MEMO

RE: Supplemental Application Materials for
VR-2018-005, NR-2018-002, and DEV-2018-006

HARMONY PARK TOWNHOMES PH II

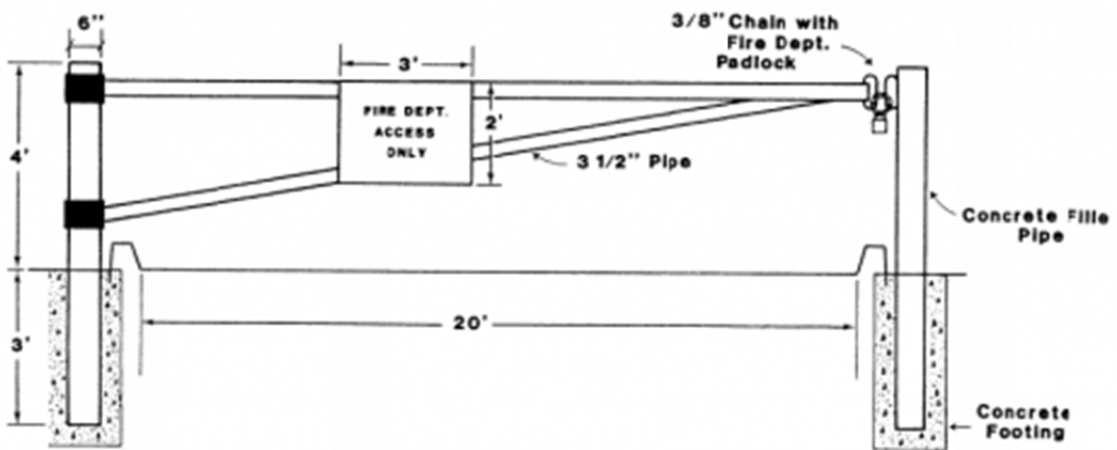
Item 4a. It is Unclear Where the Structures are on the Adjacent Lot to the East. Potential Impacts to the Property Should be Discussed and Proposed Mitigation Measures Should be Identified.

The attached WQR & Side Yard Impacts/Tree Removal Plan provides a plan view of the apartment buildings proposed encroachment into the side yard height plane. This plan has been revised to illustrate that the proposed building is located approximately 20-ft. from the existing carport located at 6125 SE Harmony Road. In addition, the plan demonstrates that the dwelling on the adjacent property is located approximately 36-ft. from the proposed apartment building, and the adjacent dwelling is buffered from the apartment building by the carport. The City's side yard height plane standards provide maximum benefits when a single-family structure and a multi-family structure are each located 5-ft. from a common property line. However in this case, the proposed distance

and buffering between the buildings help to mitigate impacts from the variance request. To further mitigate impacts created by the variance request, the WQR & Side Yard Impacts/Tree Removal Plan indicates that the applicant will retain an existing tree between the structures. In addition, the attached Parking/Side Yard/WQR Planting Areas Plan indicates that the applicant will be planting an evergreen hedge along a portion of the east property line.

PRELIMINARY SITE PLAN
 SEPTEMBER 4, 2018

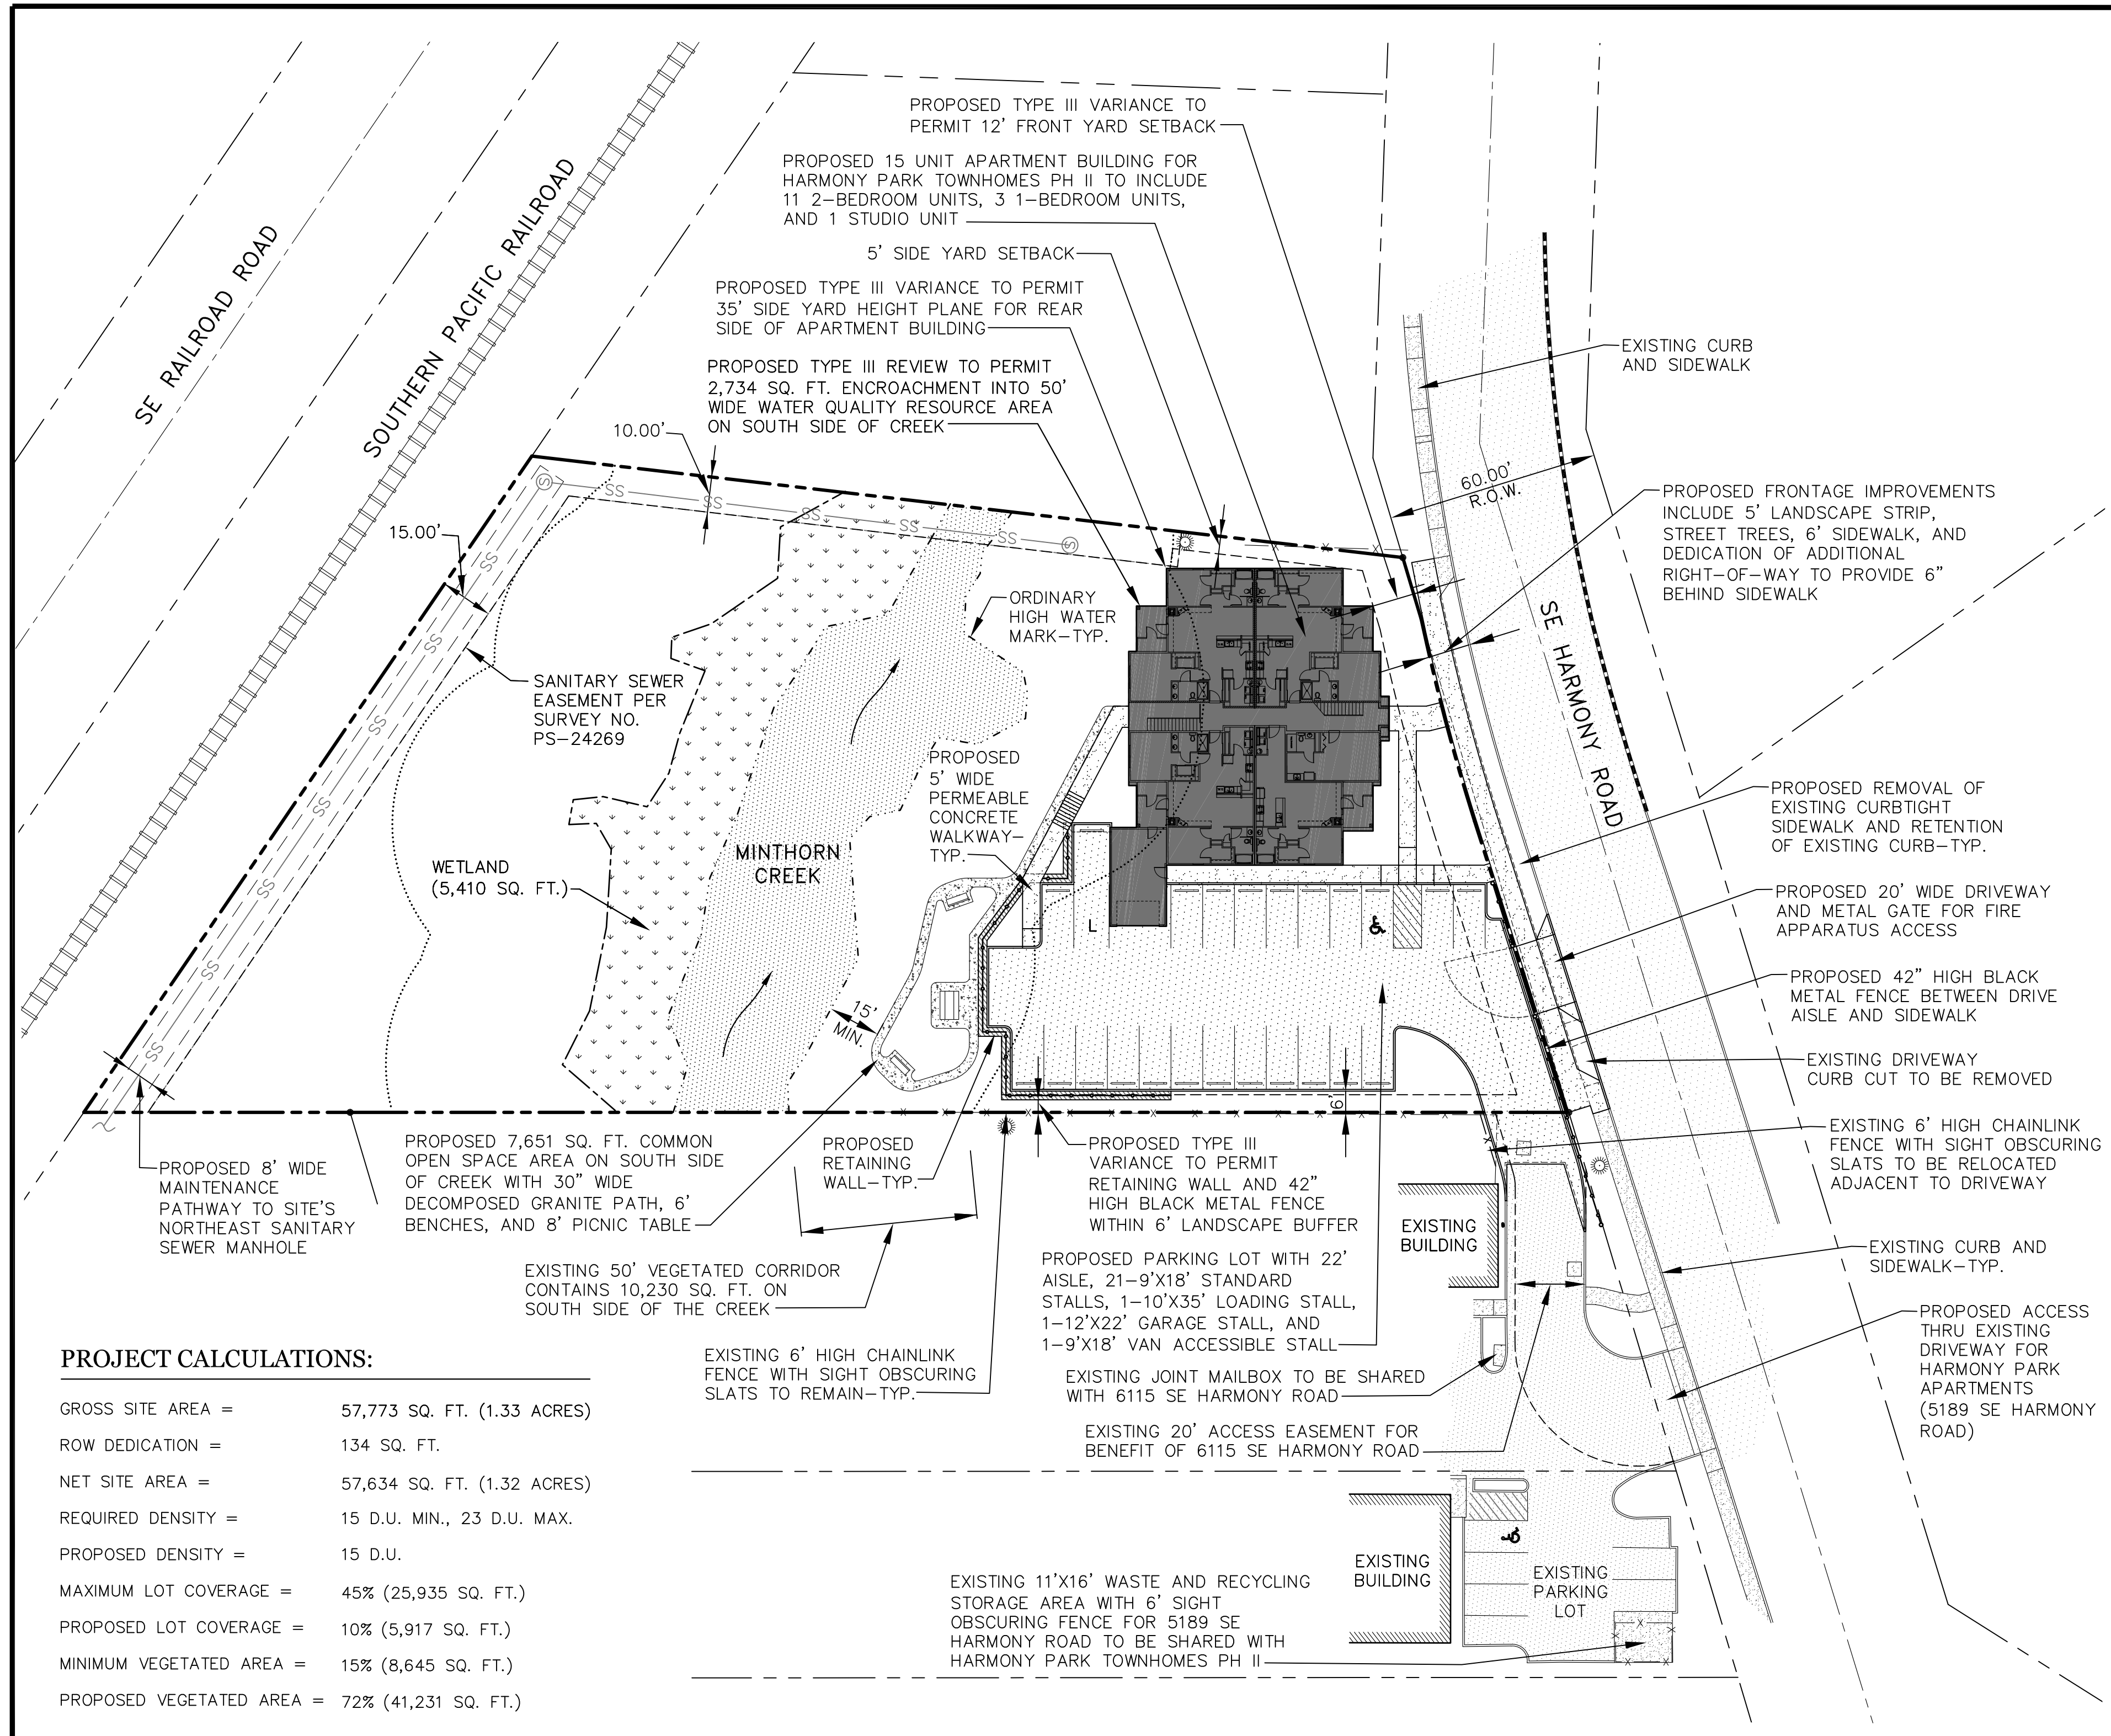
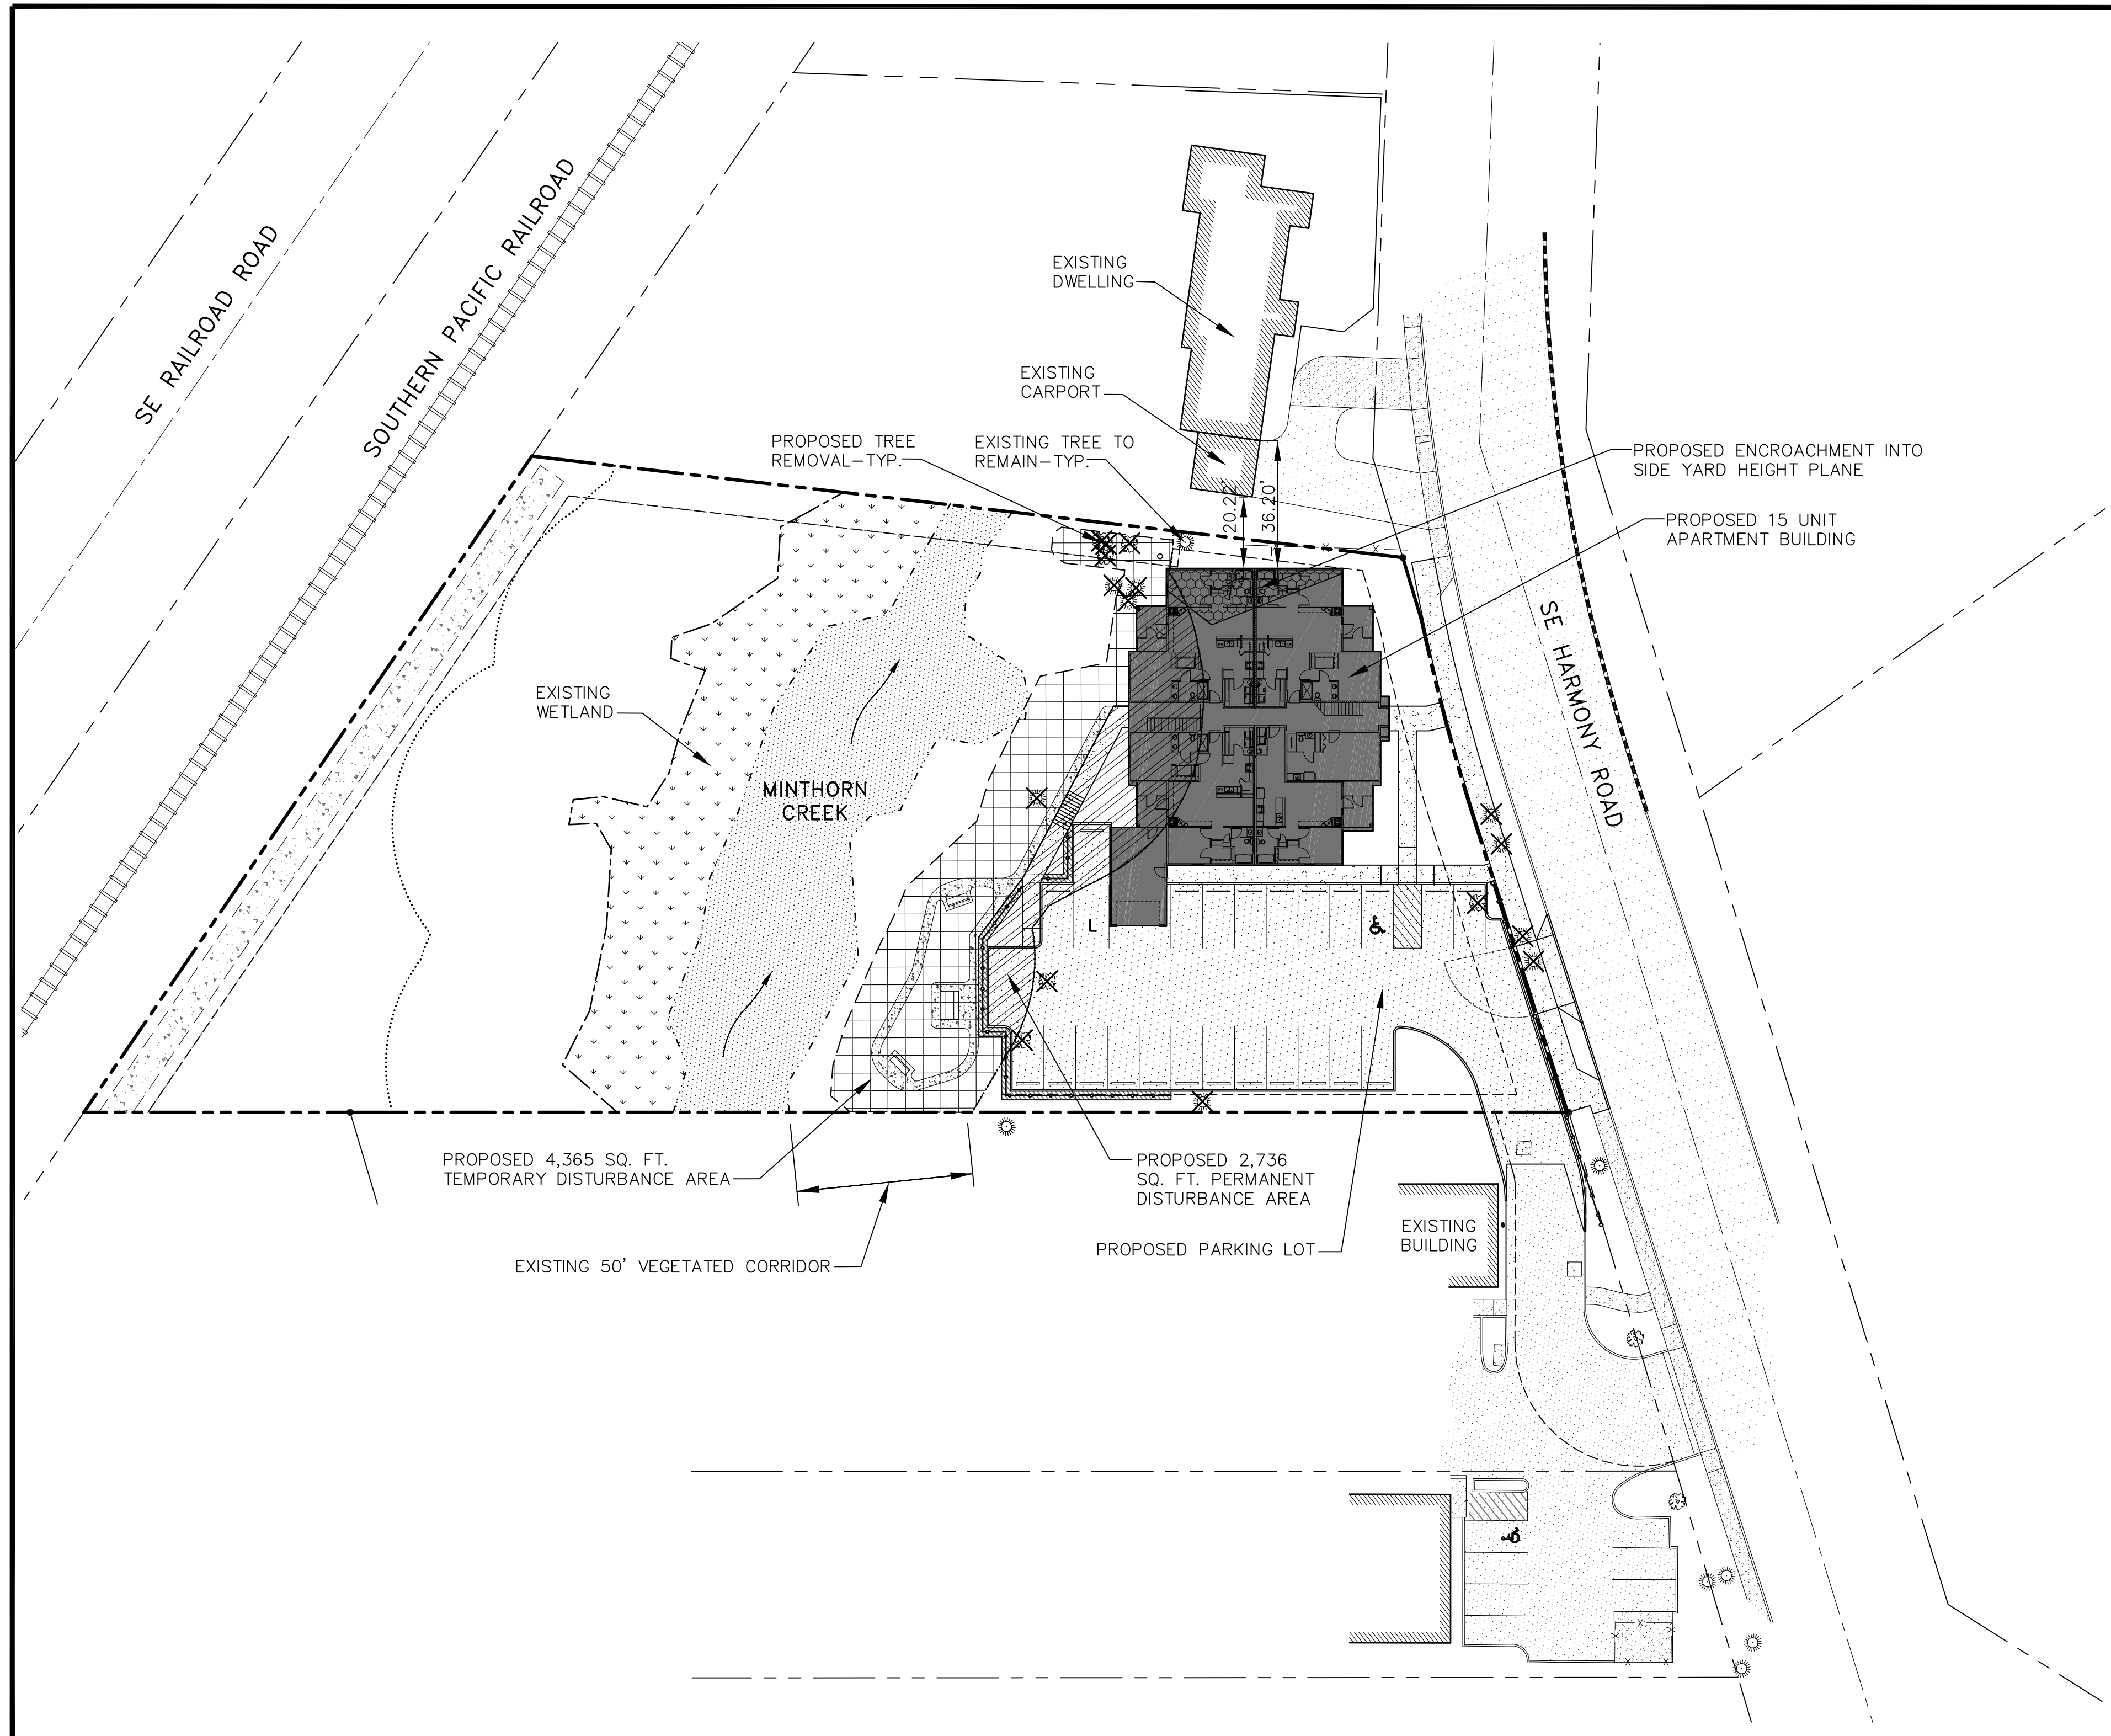
Item 2b. *An Additional Variance is Required if Permeable On-Site Walkways are Not Proposed with the Development.*

Item 2d. *More Detail is Required to Demonstrate that the Chain Link Fencing Meets the Building Materials Standards. Additional Detail is Requested for the Proposed Metal Fence and Gate along the Sidewalk. Staff Again Asserts that Stone Veneer and Cedar-Shake Patterned Hardi Board do not Function to Create a Simple and Visually Interesting Building.*

To comply with MMC Subsection 19.504.9, the applicant has attached a revised Preliminary Site Plan that proposes the installation of permeable concrete on-site walkways throughout the development. As such, an additional variance request is not required for the application.

The revised Preliminary Site Plan indicates that the applicant is no longer proposing chain link fencing. The applicant is now proposing to install 42" high black metal fencing on top of the proposed retaining wall. The same fencing is also proposed to be installed between the sidewalk along SE Harmony Road and the access drive for the apartment complex. Attached with this Memo is a picture of the proposed 42" fencing and a detail which illustrates the proposed gate for fire apparatus access. As explained above, the applicant has removed the stone veneer and cedar-shake patterned Hardi Board from the proposed apartment building.
